Owner Change Order

Change Order Number: 003

City of Norman - North Base Complex Phase 1
1310-1380 DA Vinci Street
Norman, Oklahoma 73069

The Contract is hereby revised by the following items:

2
E3-01 1/8" = 1'-0"
PLAN NORTH

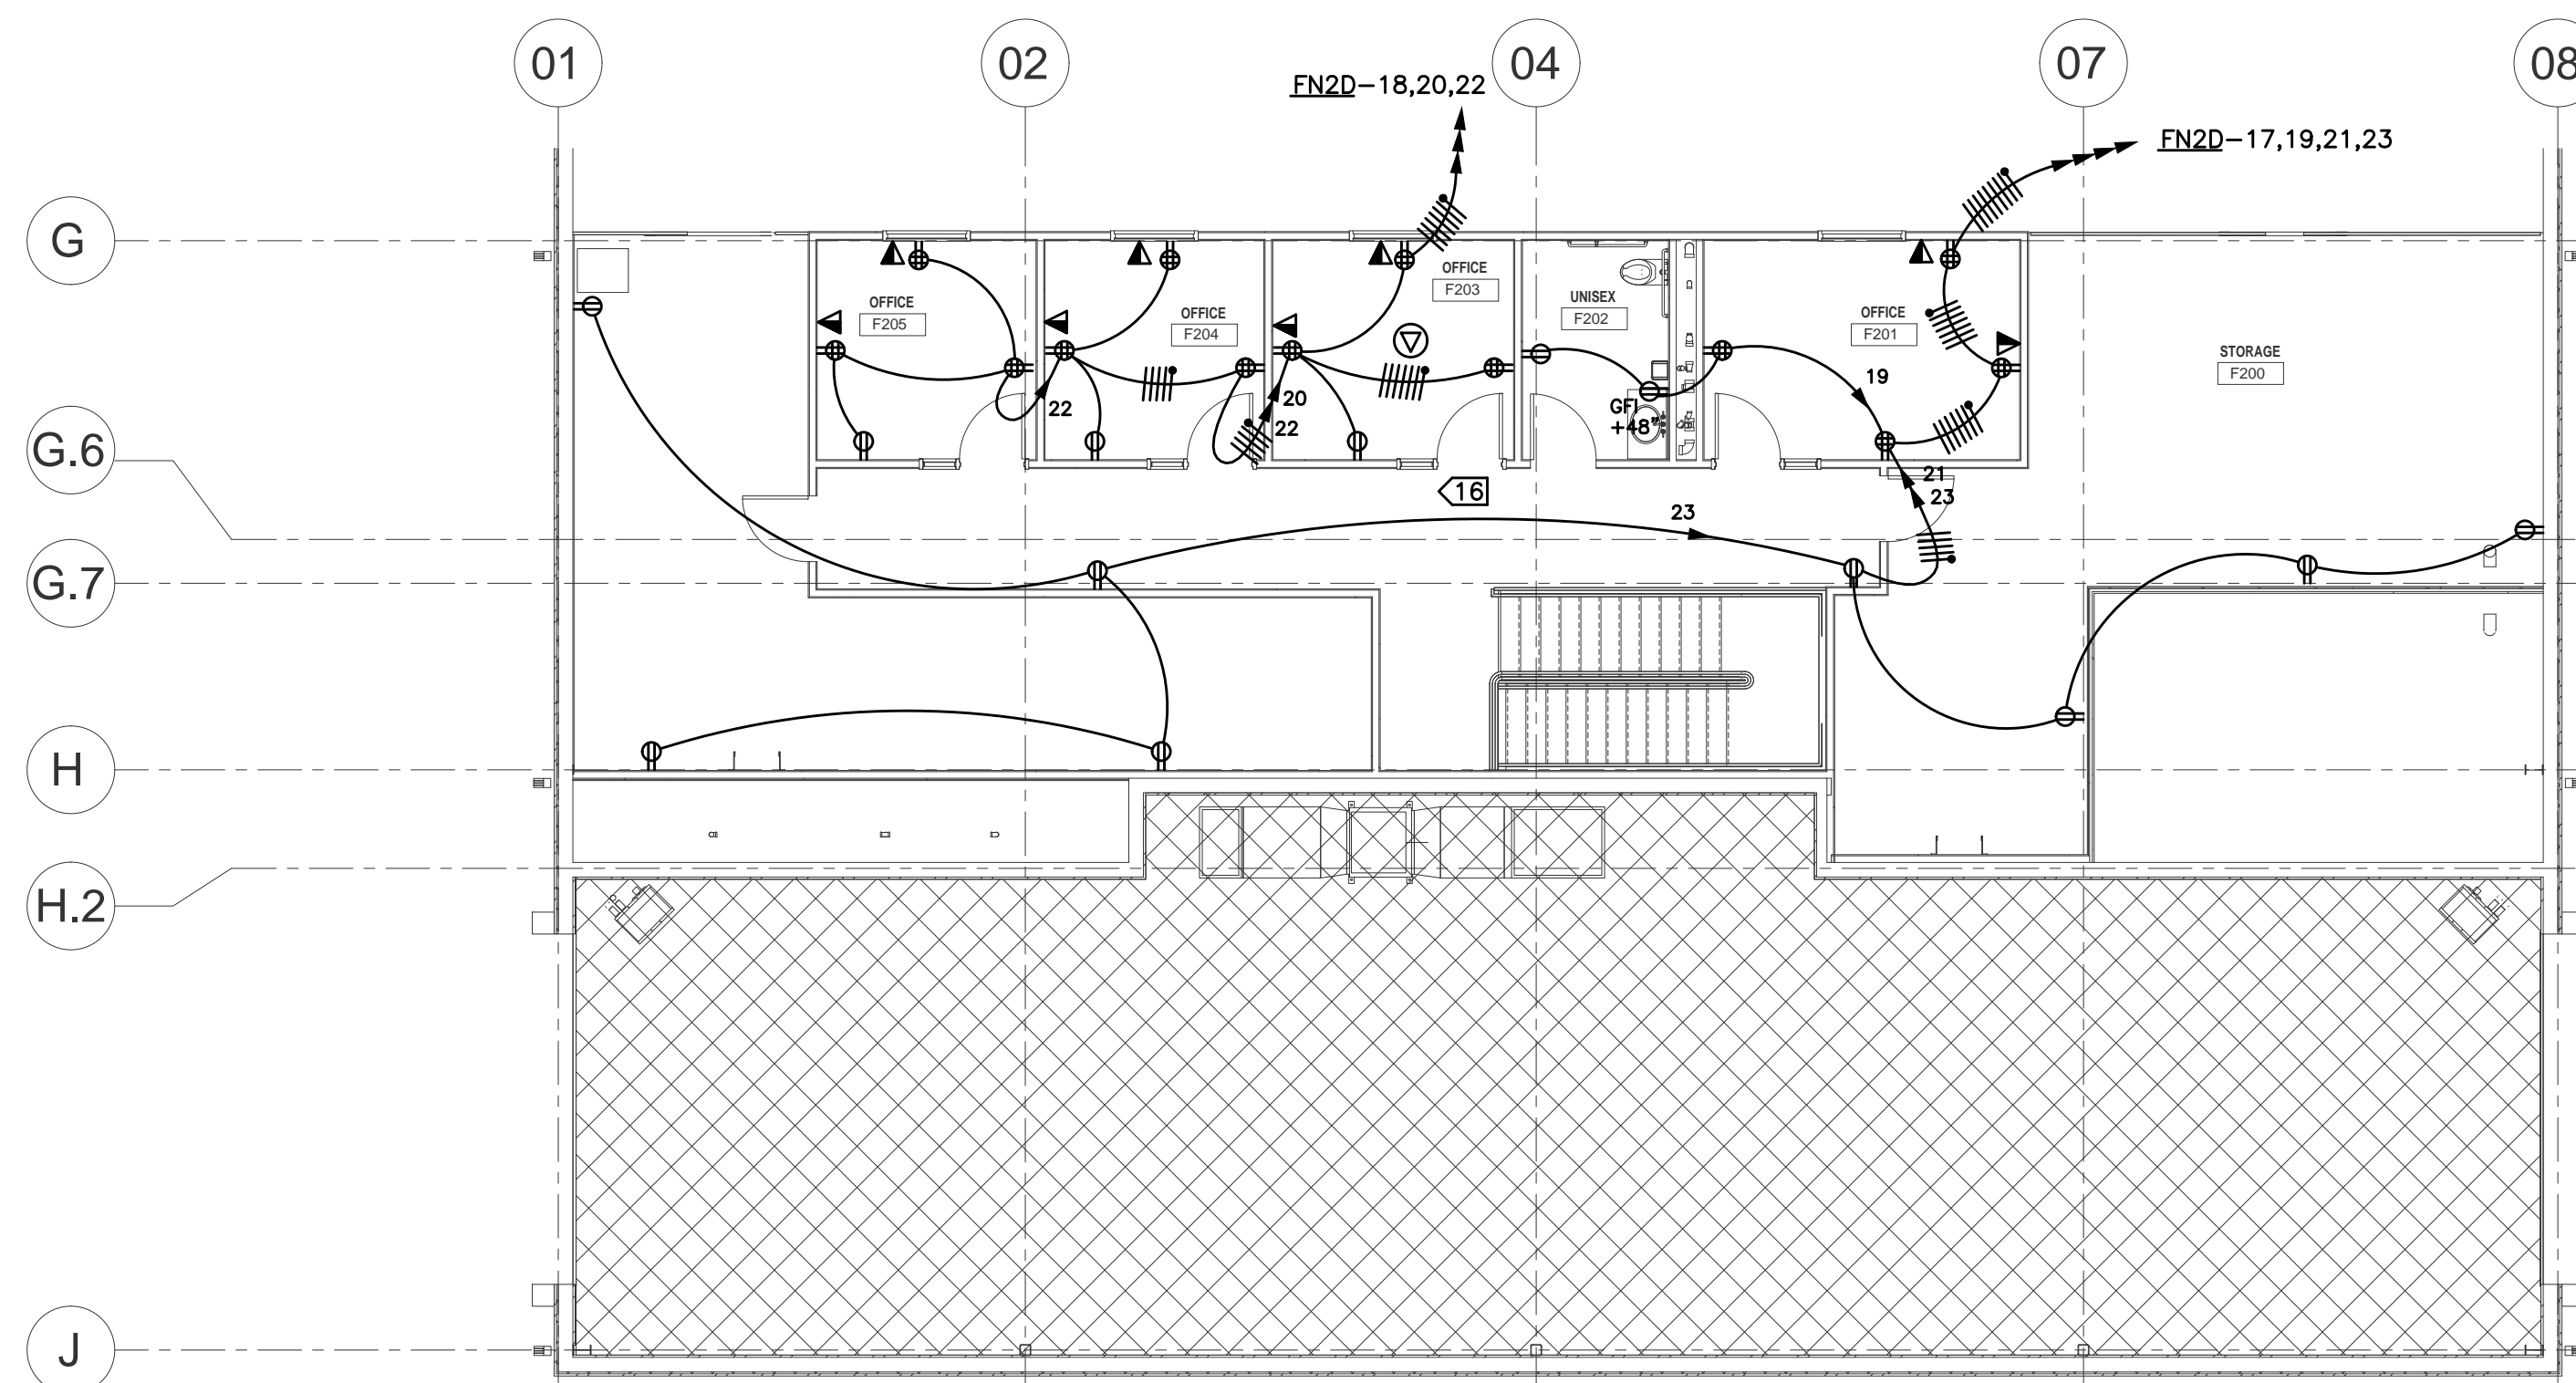
Item	Qty	Unit	Description	Labor Hours	Ext	Material	Ext	Open	Ext
1			added 2 data roughs, circuit for forklift, and						
2			circuit for drug test controller						
3									
4	2	e	10' sticks of 3/4" emt for data rough			12.50	25.00		
5	2	e	4sqr for data rough			5.00	10.00		
6	2	e	2 hours 1 man labor	1	2.00				
7									
8	13	e	10' sticks of 3/4" emt for fork lift			12.50	162.50		
9	1	e	3/4" seal off			25.00	25.00		
10	390	e	130 x 3 of #12 thhn			0.25	97.50		
11	6	e	6 hours labor	1	6.00				
12									
13	1.5	e	10' stick of 3/4" emt for drug test station			12.50	18.75		
14	2	e	4sqr boxes			5.00	10.00		
15	60	e	20' x 3 of #12 thhn			0.25	15.00		
16	3	e	3 hours 1 man labor	1	3.00				
17									
18									
19									
20									
21									
22									
23									
24									
25									
26									
27									
28									
29									
30									
31									
32									
Totals				3	11.00		363.75		0.00

DRAWING TITLE
FLEET MAINTENANCE BUILDING ABOVEFLOOR PLUMBING PLAN

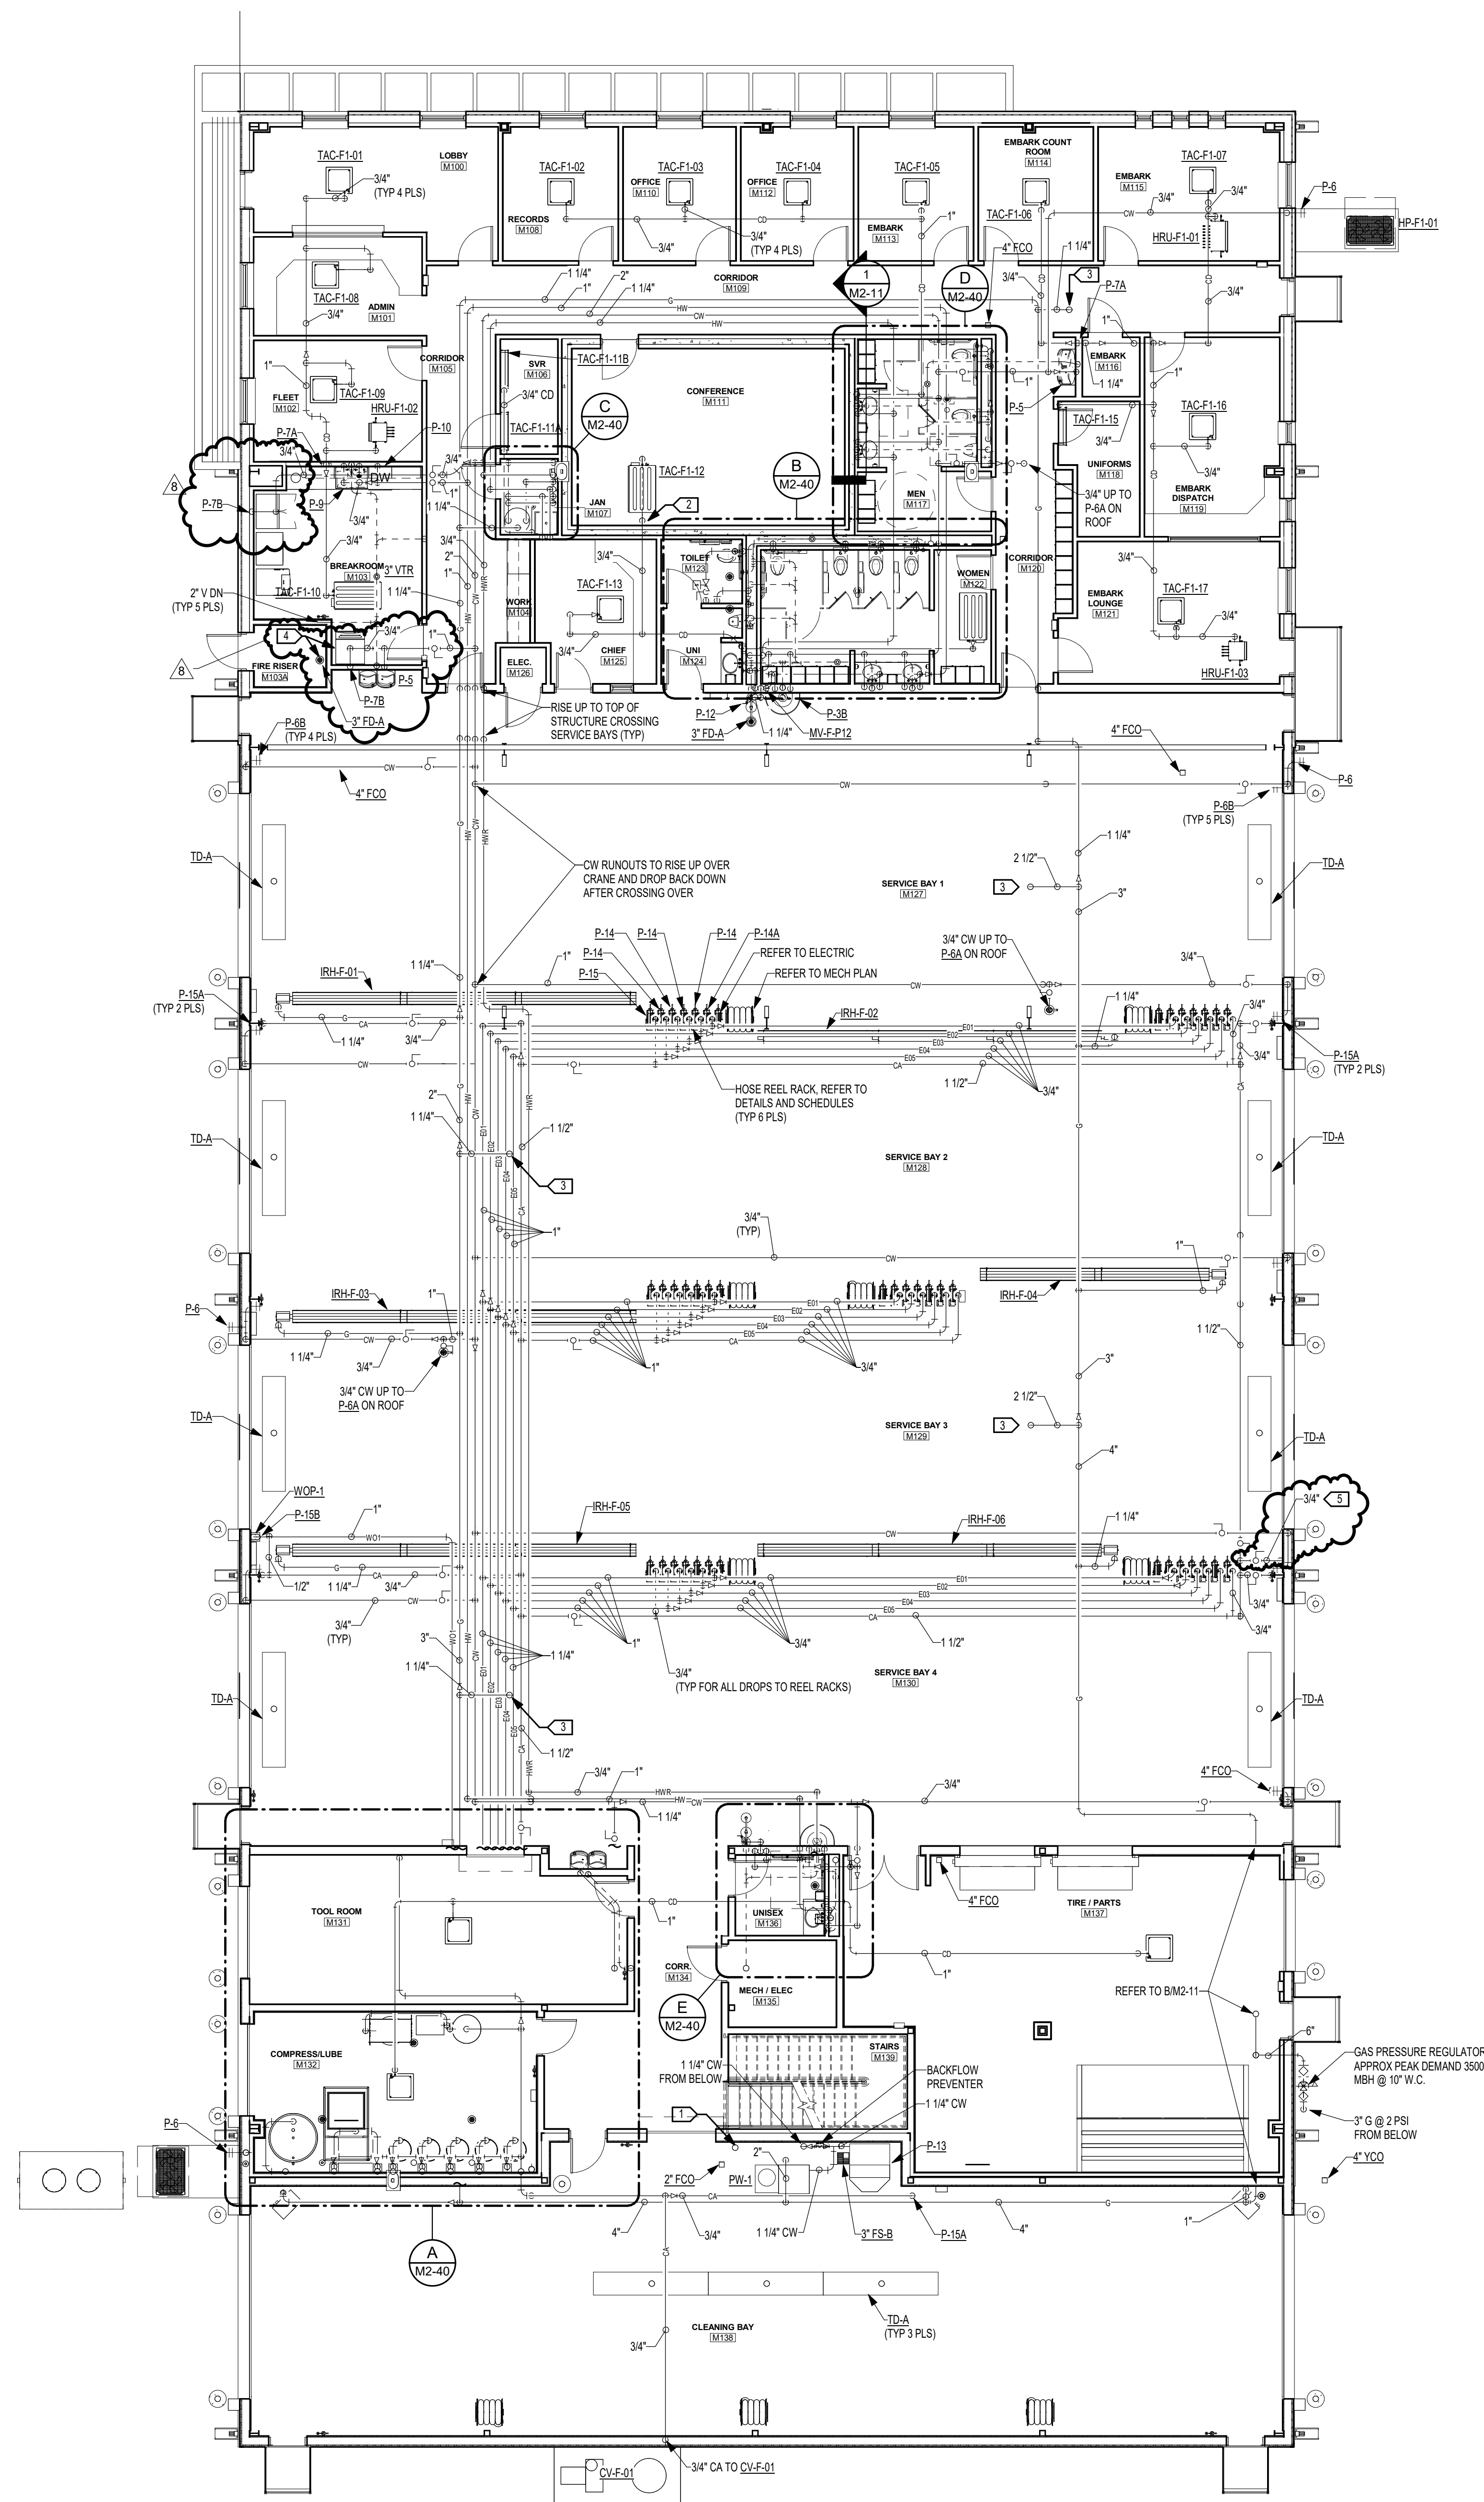
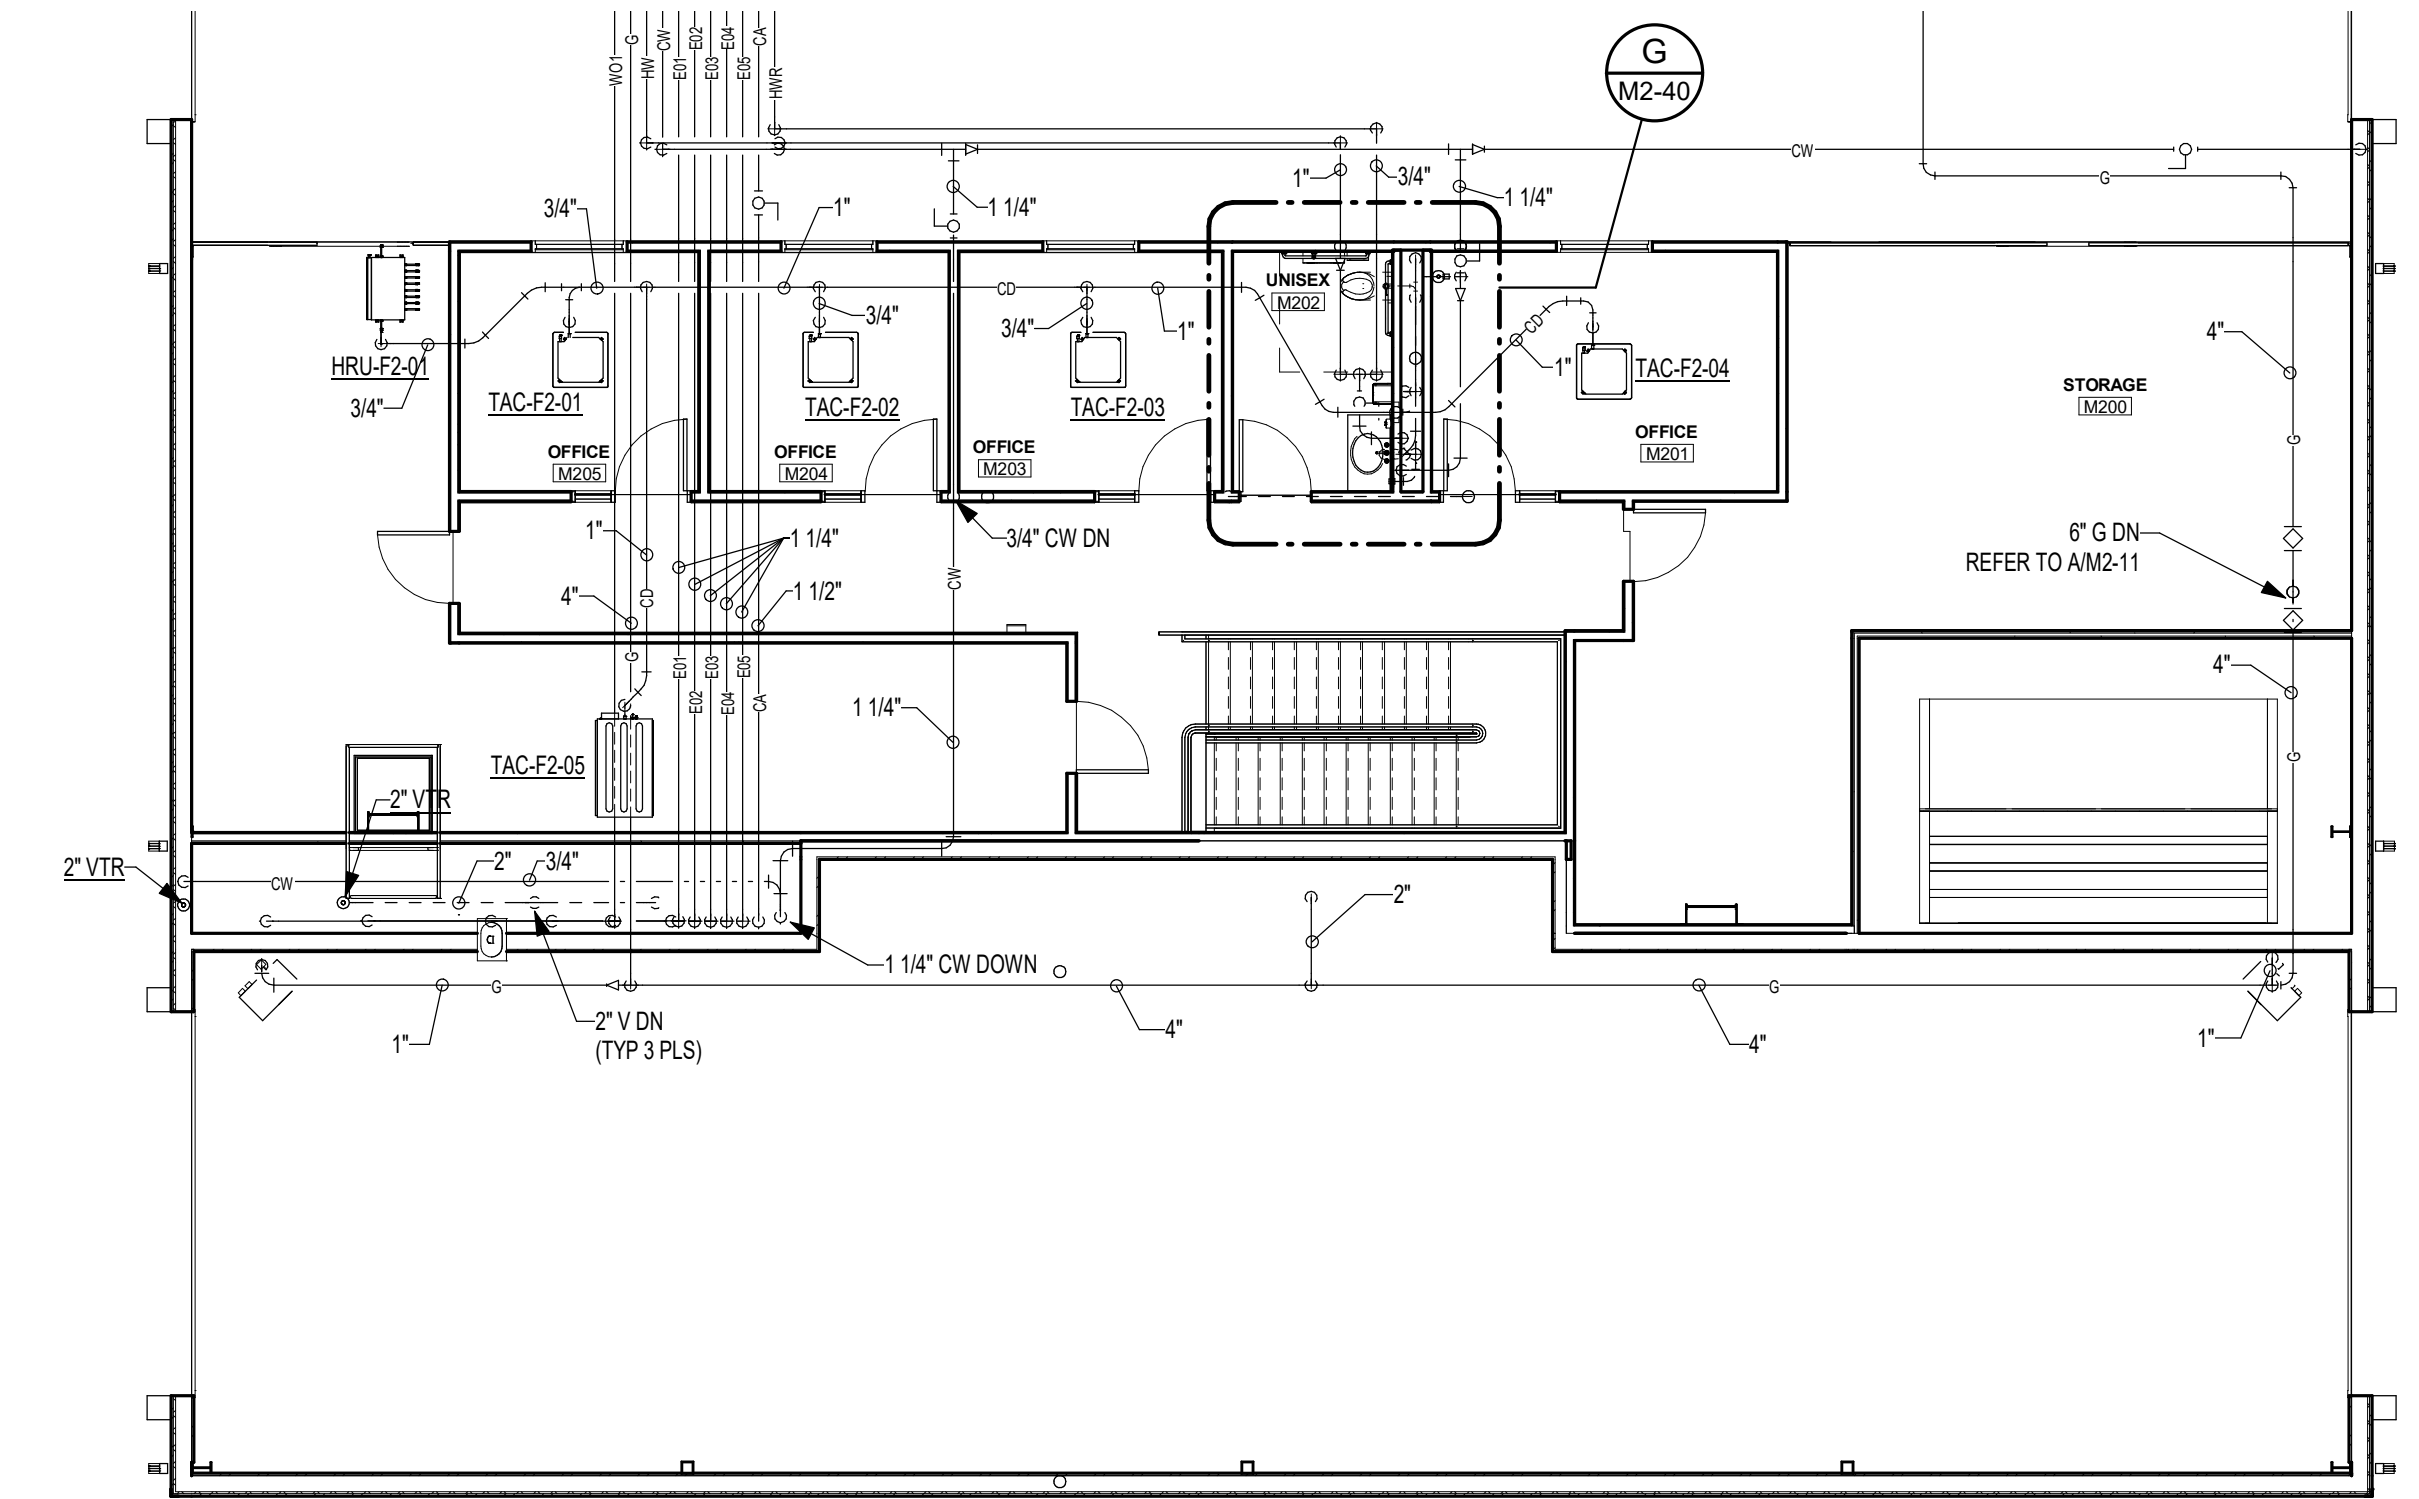
NOTE: INCLUDES PROVIDE DEDICATED 3/4" COMPRESSED AIR LINE APPROX. 20'-0" TO VEHICLE LIFT CONTROLLER, INSTALLED IN ACCORDANCE WITH LIFT MANUFACTURERS RECOMMENDATIONS.
